Addendum No. 1
August 23, 2024

Project: KOA – Rapid City Office
Rapid City, South Dakota
#3017

Architect: Architecture Incorporated

7.20

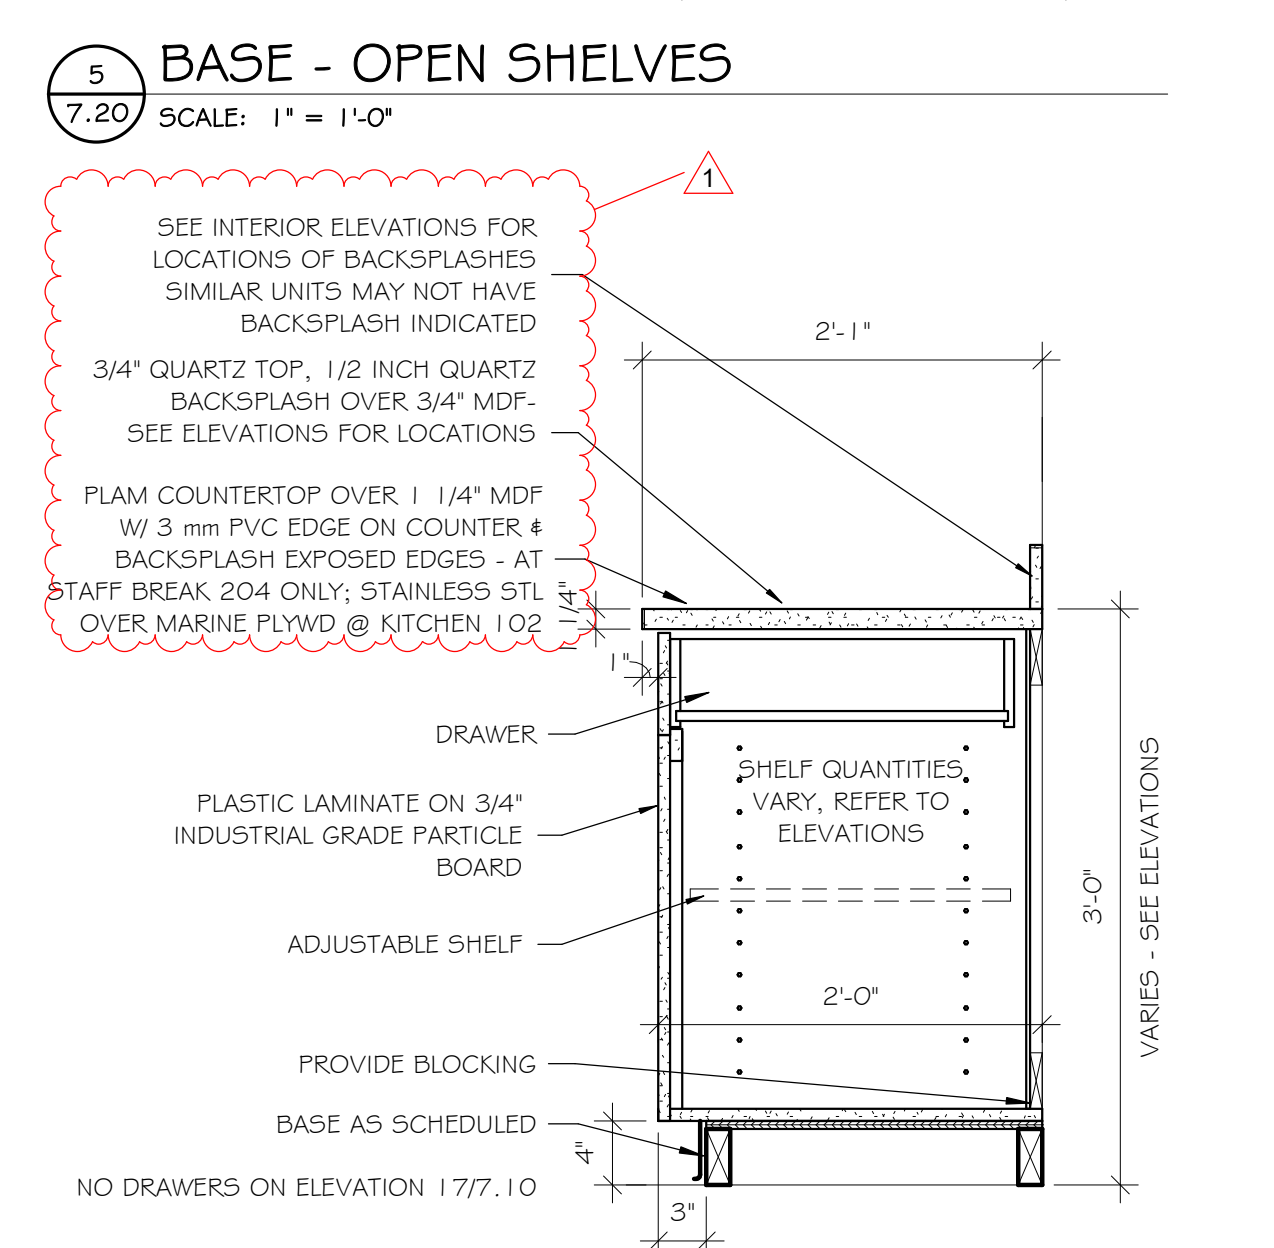
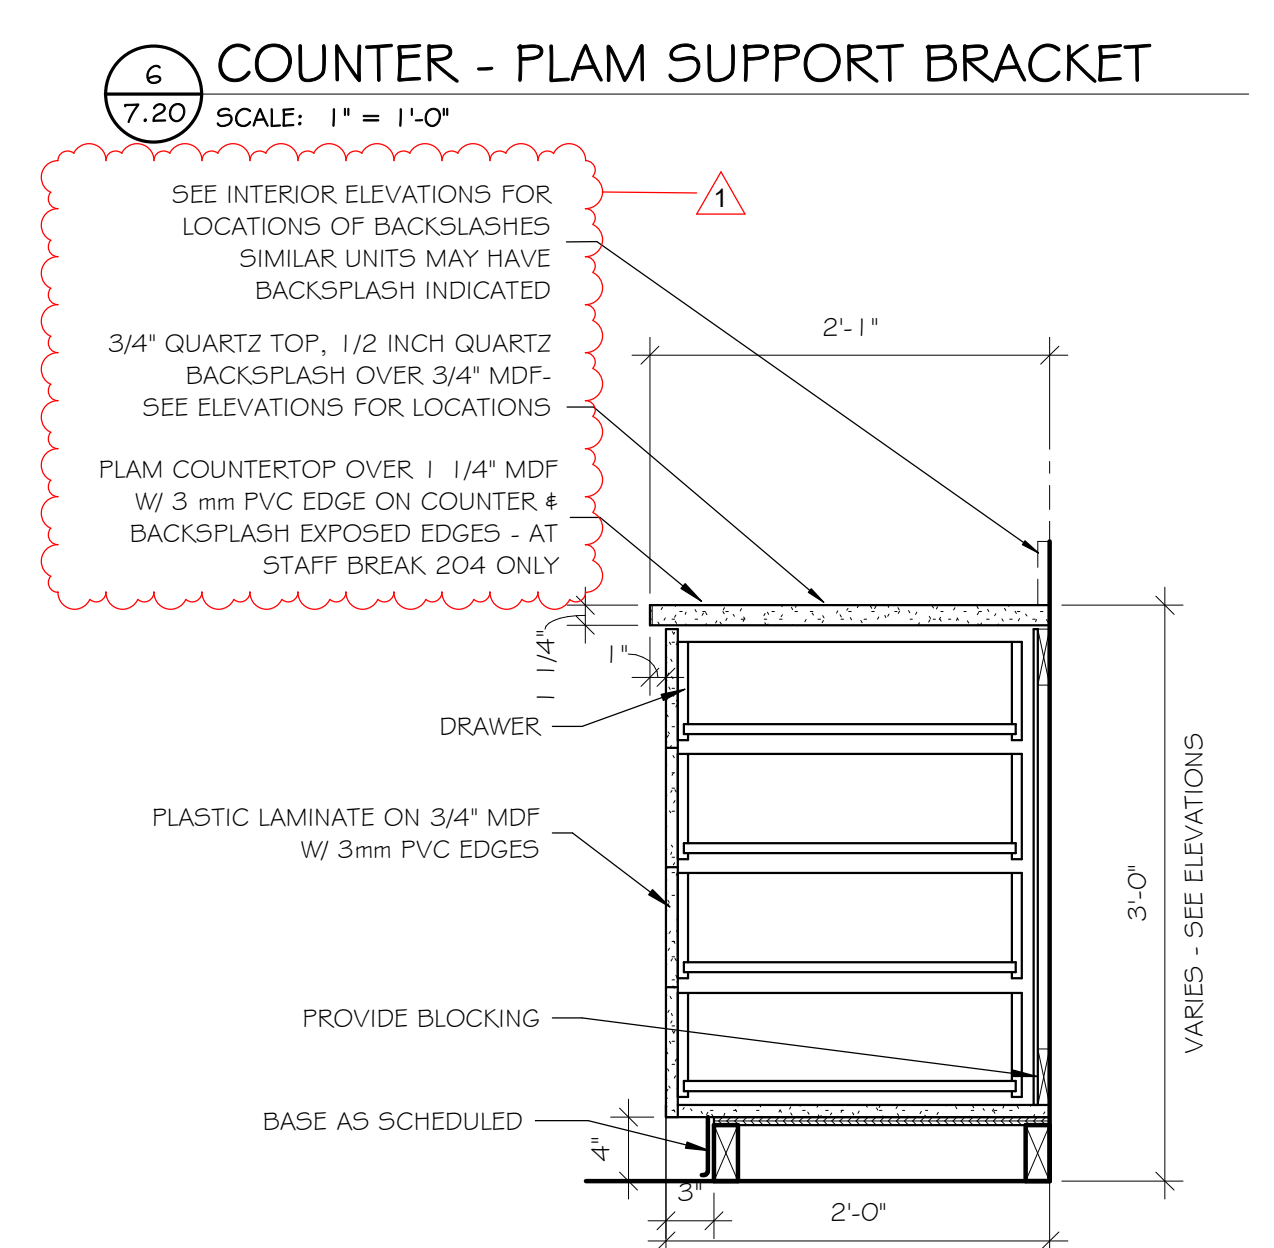
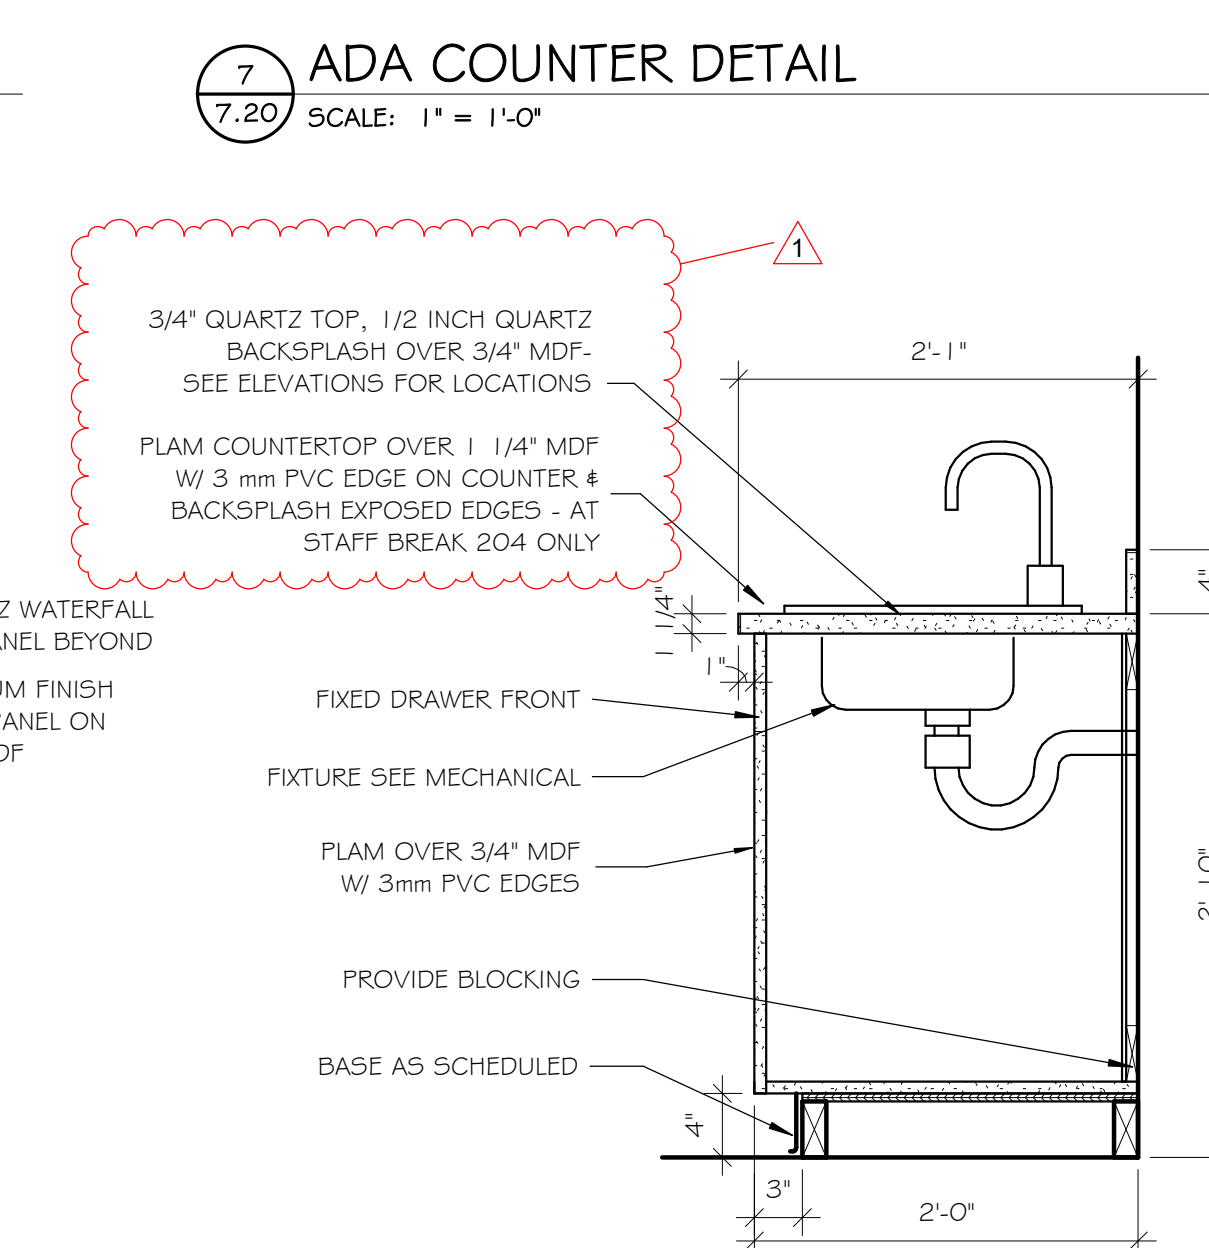
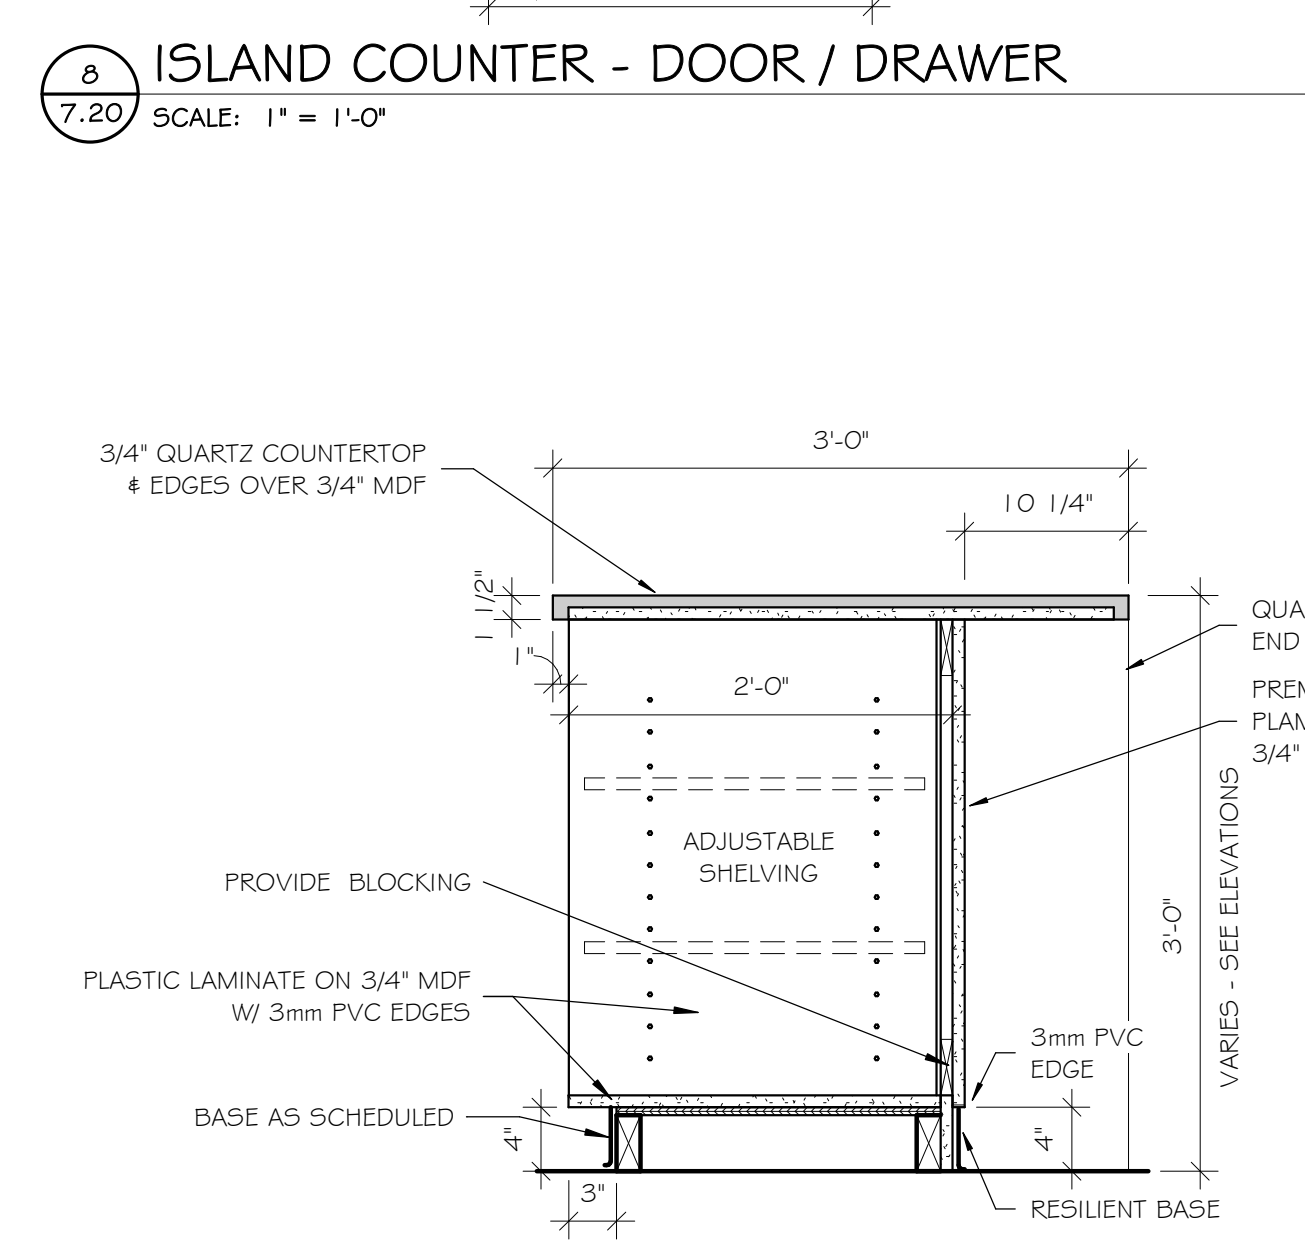
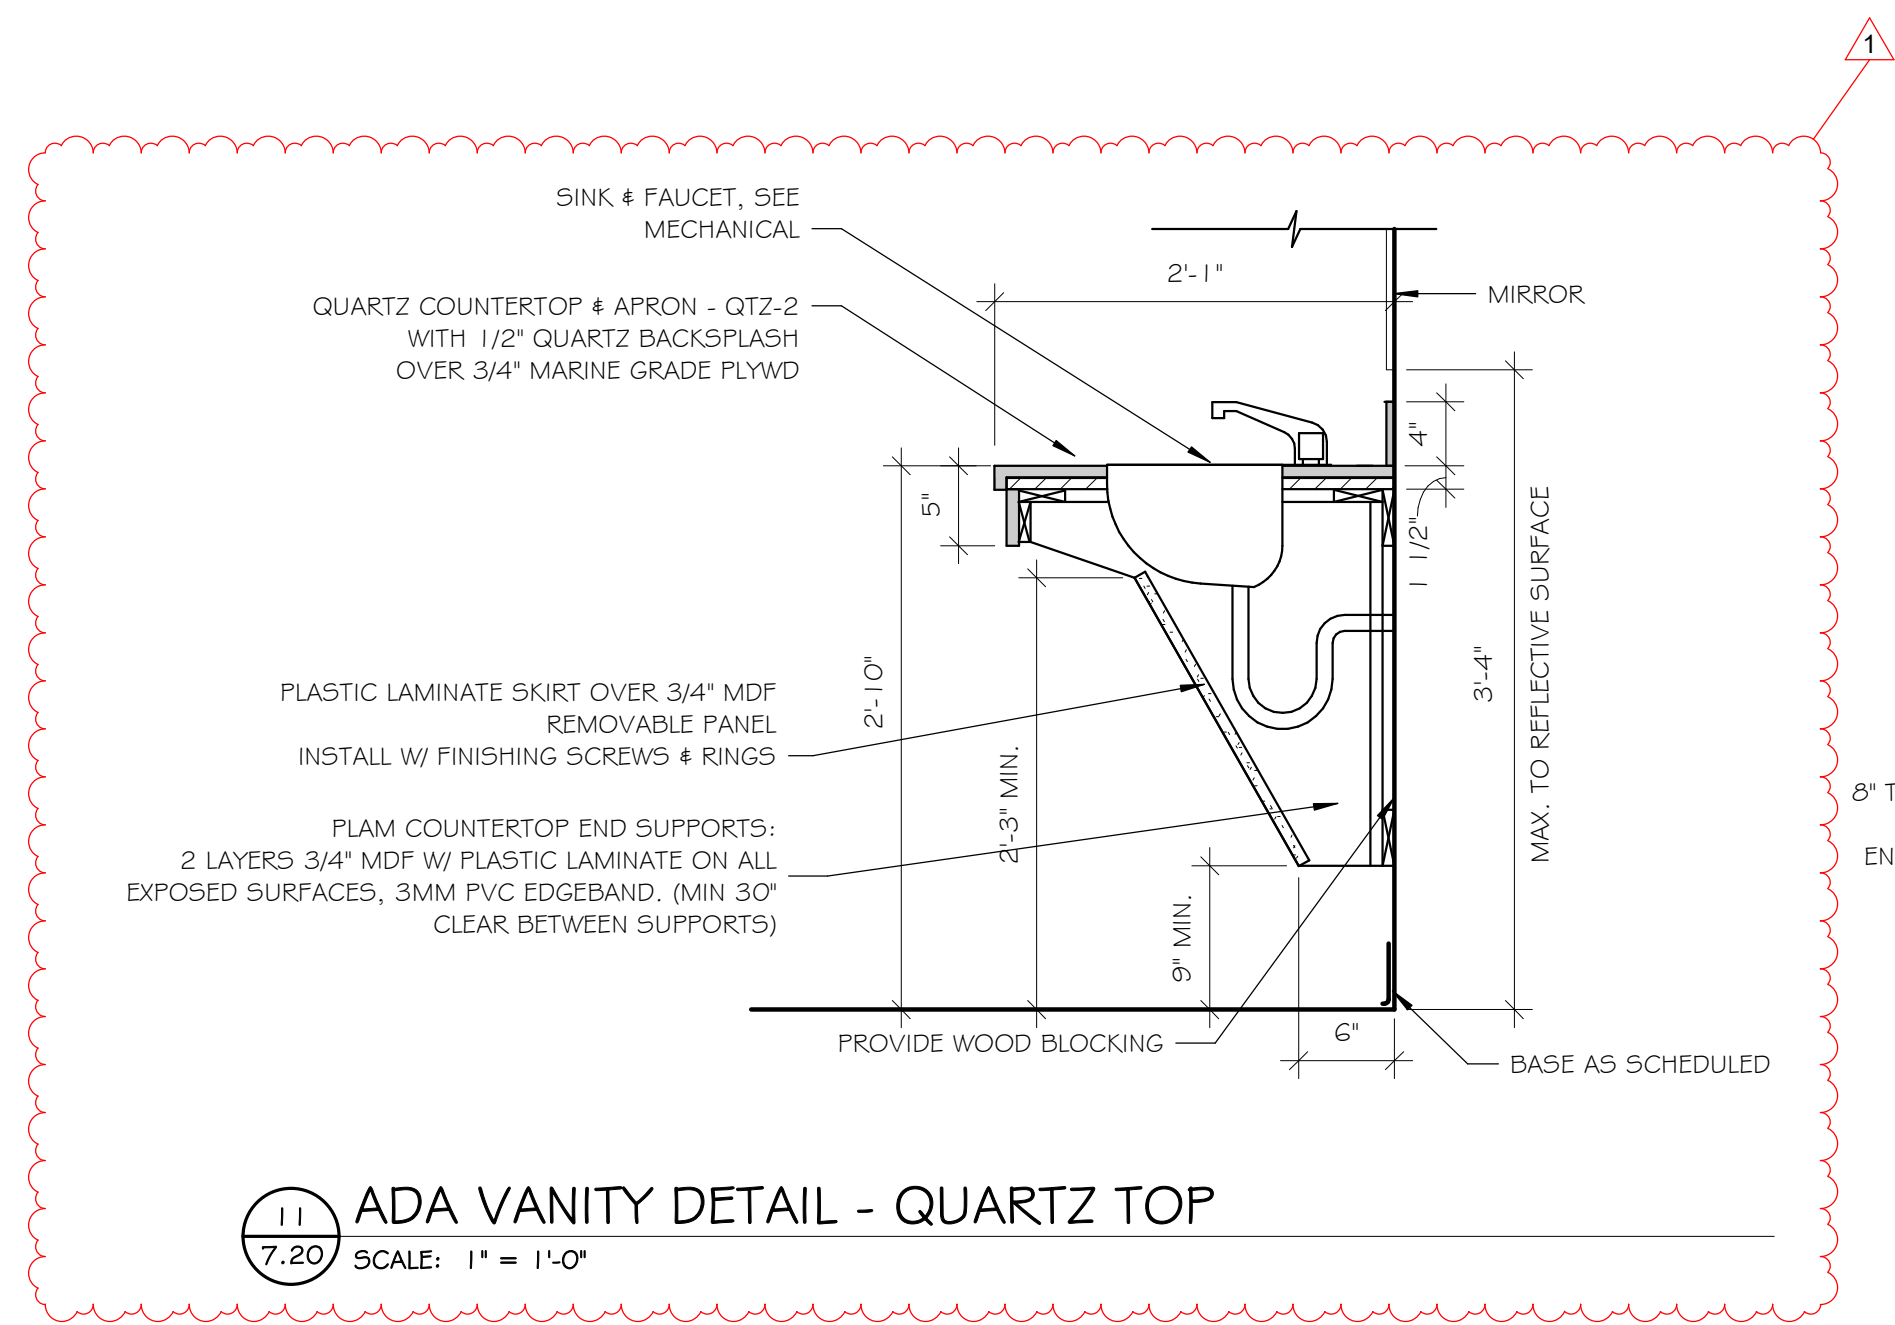
14) DRAWING 7.20– CASEWORK SECTIONS

- a) Add Section 11/7.20 “ADA Vanity Detail – Quartz Top”. All Bath vanities are to have Quartz-2 countertops.
- b) See revised sections reflecting countertop material notes and other changes in attached Revised Sheet 7.20, with revisions clouded and noted as “1”.
